**MONITORING YEAR 3
ANNUAL REPORT
FINAL**

MCLENNY ACRES MITIGATION SITE

Subject: McClenny Acres Mitigation Site – Monitoring Year 3 Report
Neuse River Basin – HUC 03020201
Wayne County
DMS Project ID No. 100038
Contract # 7423

On February 1, 2024 Wildlands Engineering received comments from the North Carolina Division of Mitigation Services (DMS) regarding the Draft Monitoring Year 3 Report for the McClenny Acres Mitigation Site. DMS comments pertaining to the stream and wetland report are reprinted below with Wildlands' responses in italics.

FIGURES

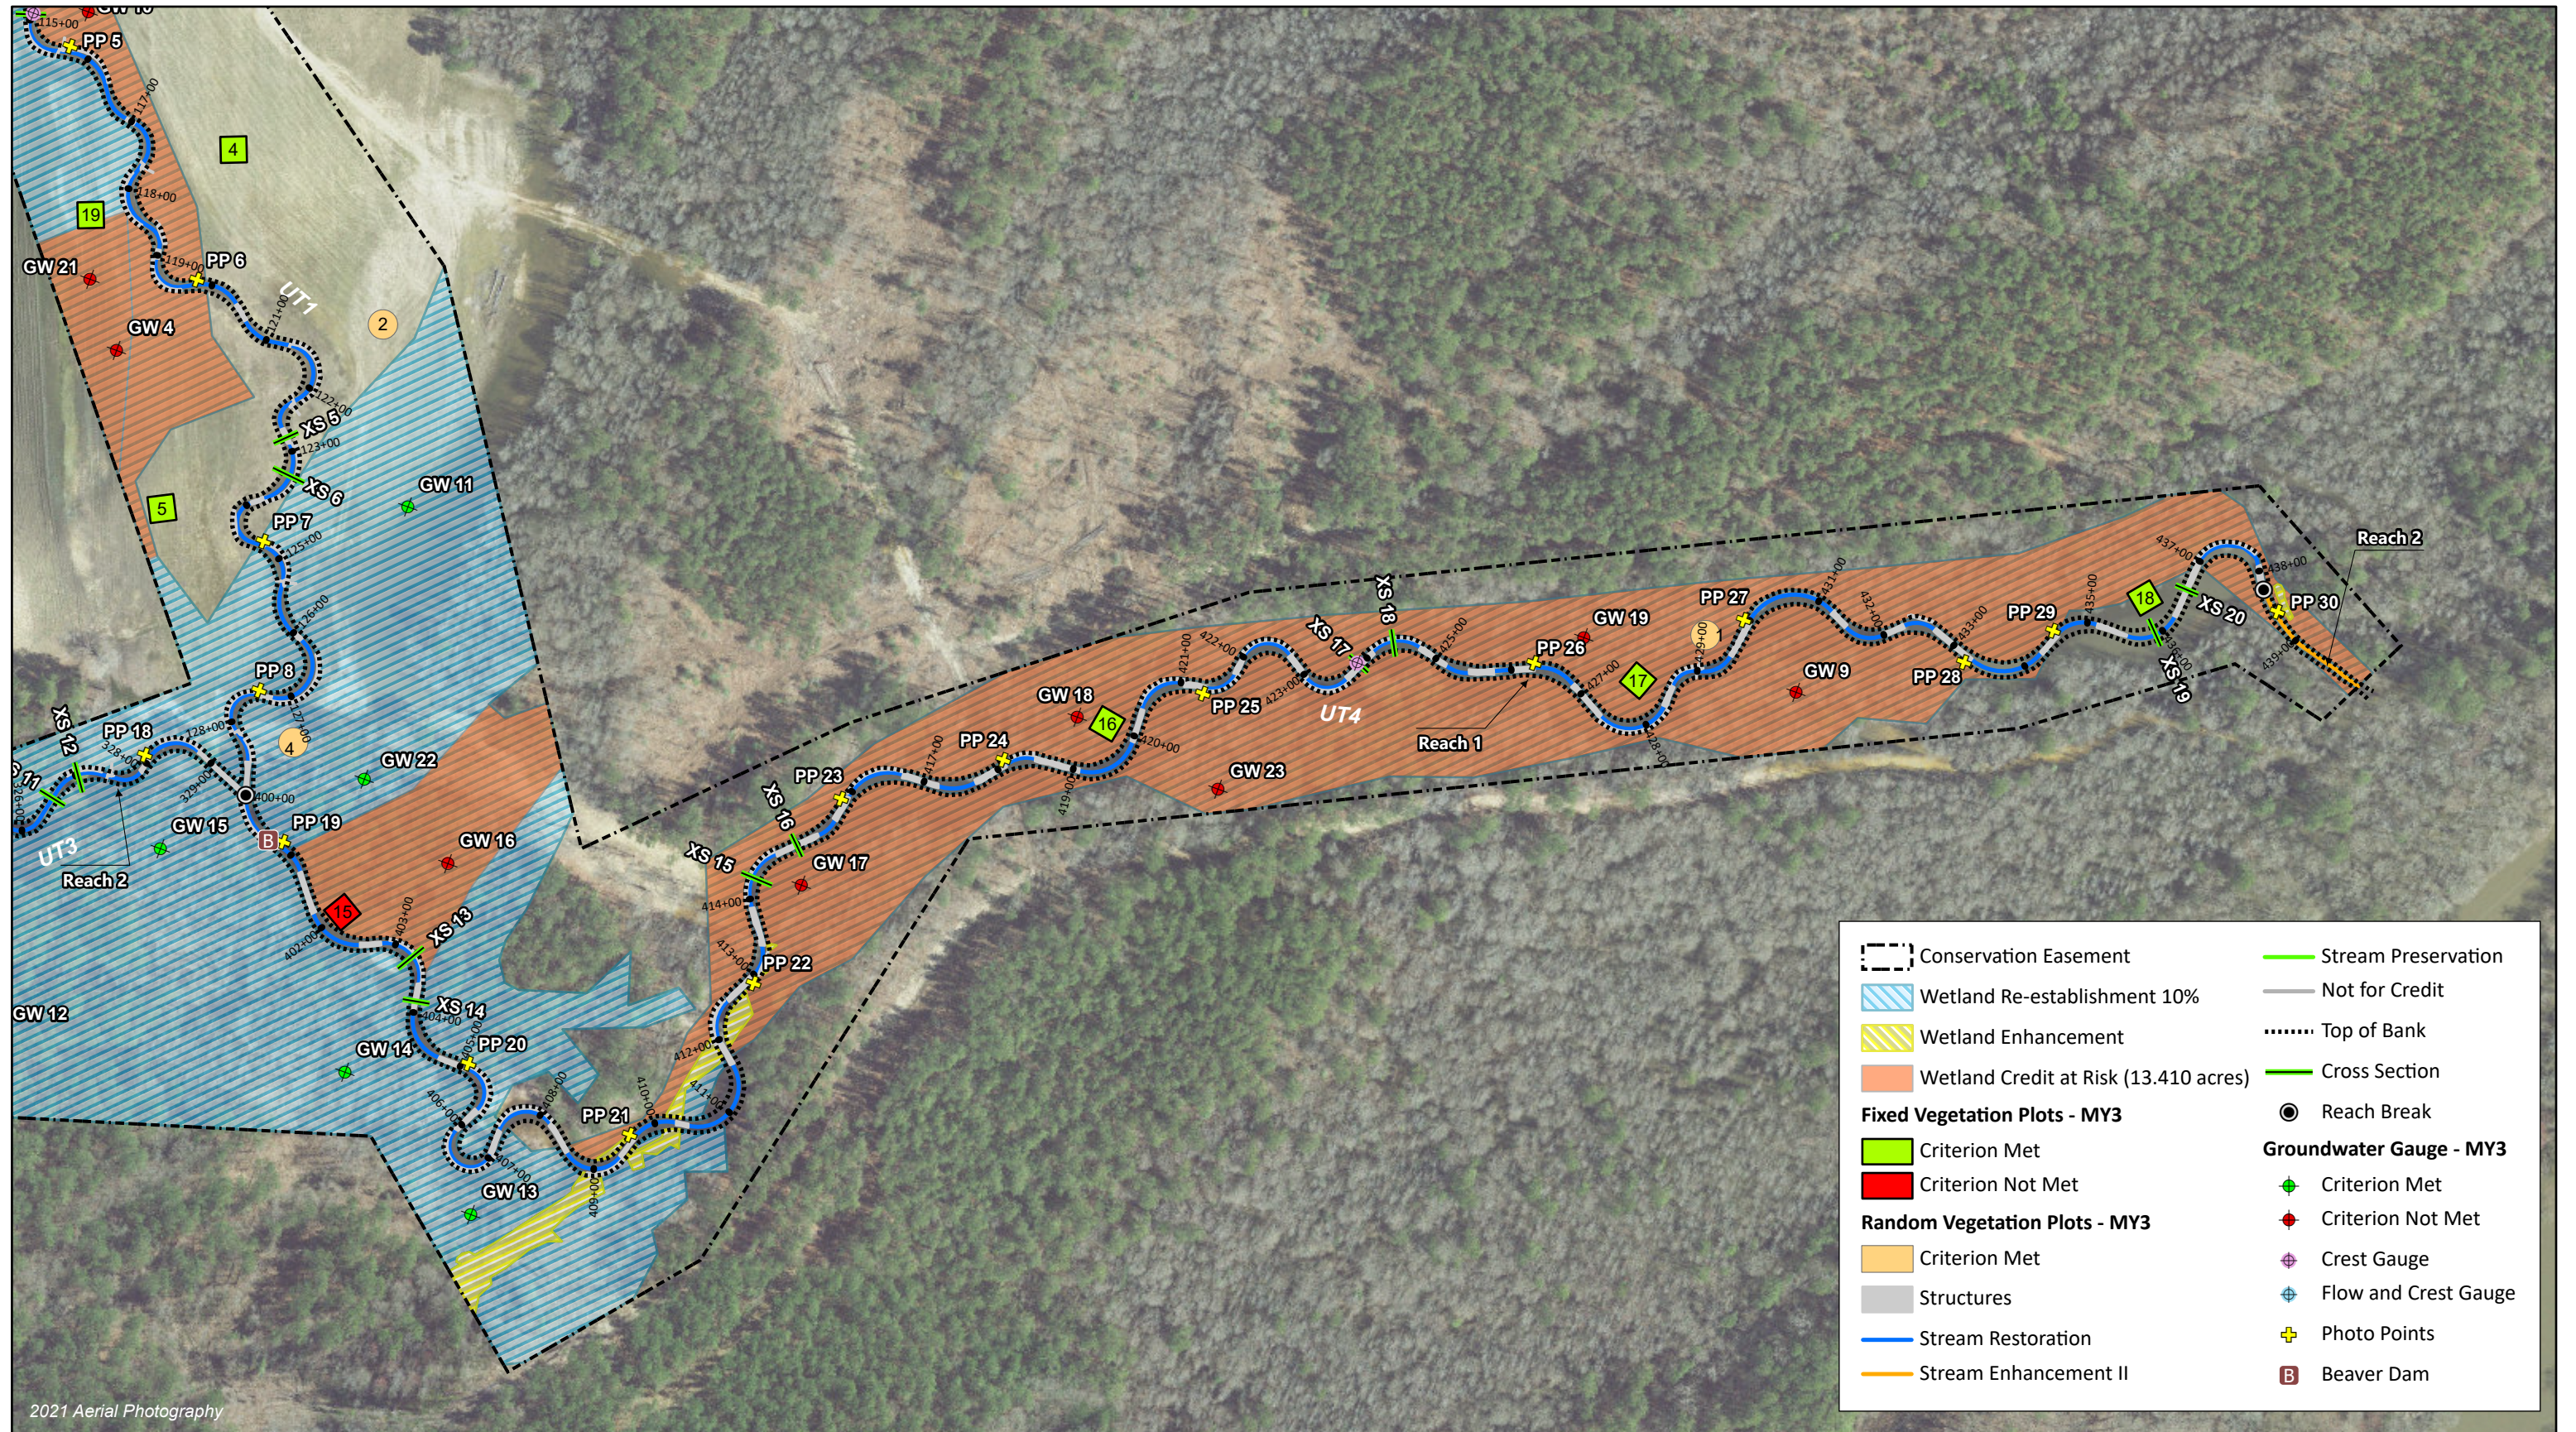
2. On Figures 1 & 1b, GW5 is mistakenly shown as not meeting success criteria.

Response: Figures were updated to correctly indicate GW 5 is meeting the success criteria.

Recorded In-Stream Flow Events Plot

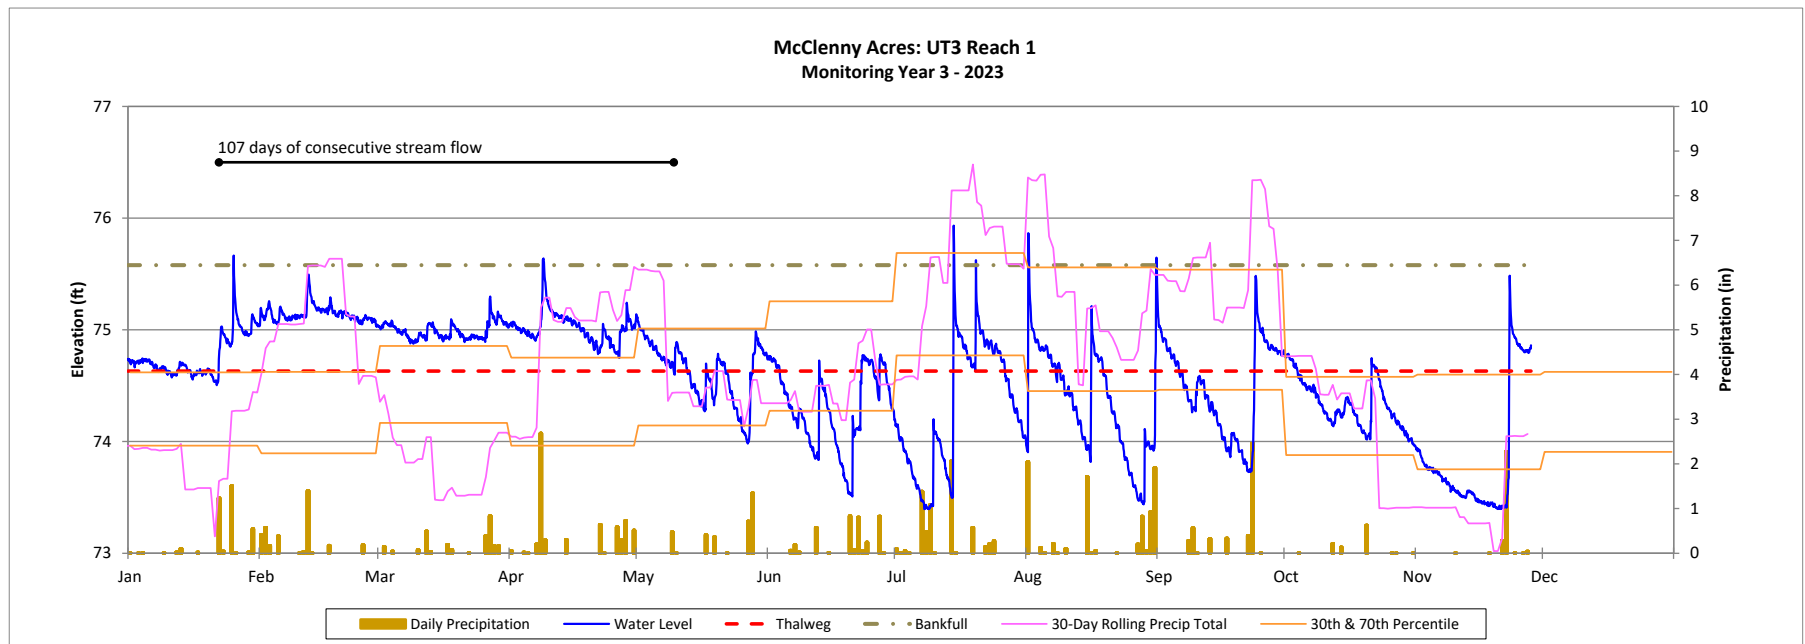
1. Table 2 reports UT3 as having 104 consecutive days of stream flow but the hydrograph says 107 days. Please correct.

Response: Table 2 was updated to indicate the correct value of 107 consecutive days of stream flow.
